SERVICE BULLETIN

MITSUBISHI MOTORS

PURPOSE : CHANGE	ISSUE NO. : MSB-14EXML15_17-001	DATE : 2014-10-02
SUBJECT : Omission of N mark for non-reusable parts and the tightening torque in the exhaust related parts.		<DESTINATION/MODEL> <M/Y> (For all destinations) As per attached sheet 1
GROUP : Gr:15(Intake exhaust)/Gr:17(Emission control)

<3.0 L ENGINE>

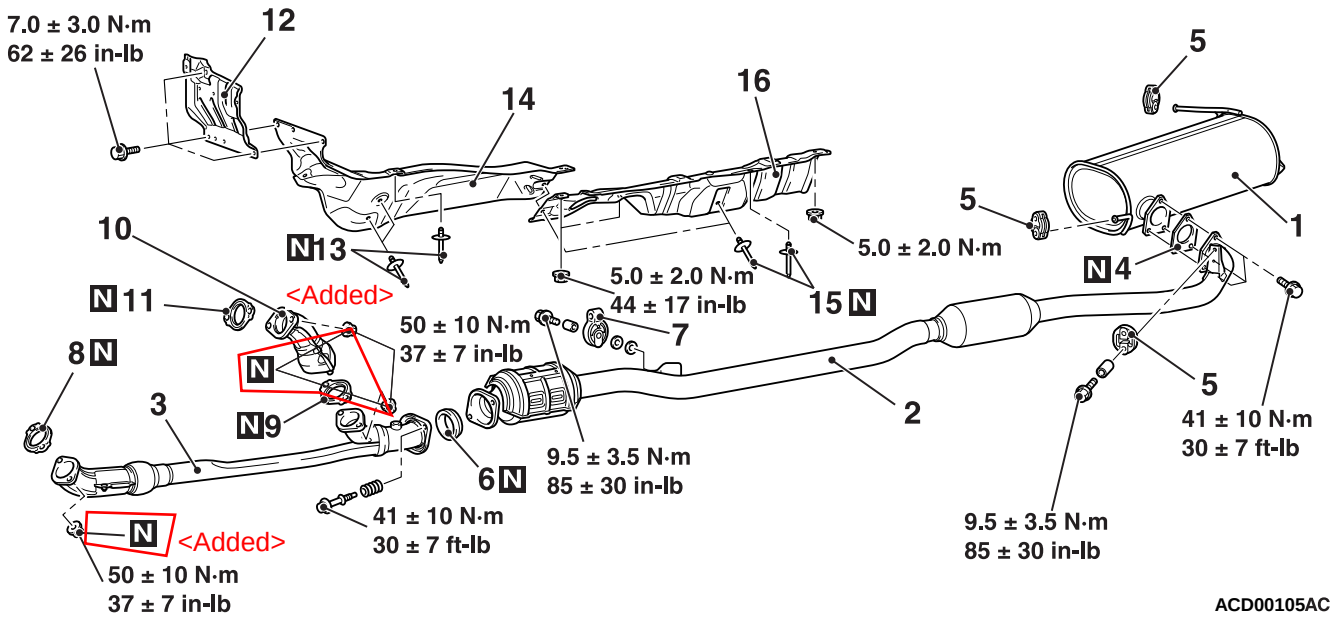
7.0 ± 3.0 N·m
62 ± 26 in-lb
12
14
16
5
5
1
10
N 13
5.0 ± 2.0 N·m
5.0 ± 2.0 N·m
44 ± 17 in-lb
15 N
N 4
N 11
<Added>
50 ± 10 N·m
37 ± 7 in-lb
7
8 N
N
3
N 9
2
5
41 ± 10 N·m
30 ± 7 ft-lb
6 N
9.5 ± 3.5 N·m
85 ± 30 in-lb
41 ± 10 N·m
30 ± 7 ft-lb
9.5 ± 3.5 N·m
85 ± 30 in-lb
N
<Added>
50 ± 10 N·m
37 ± 7 in-lb
ACD00105AC
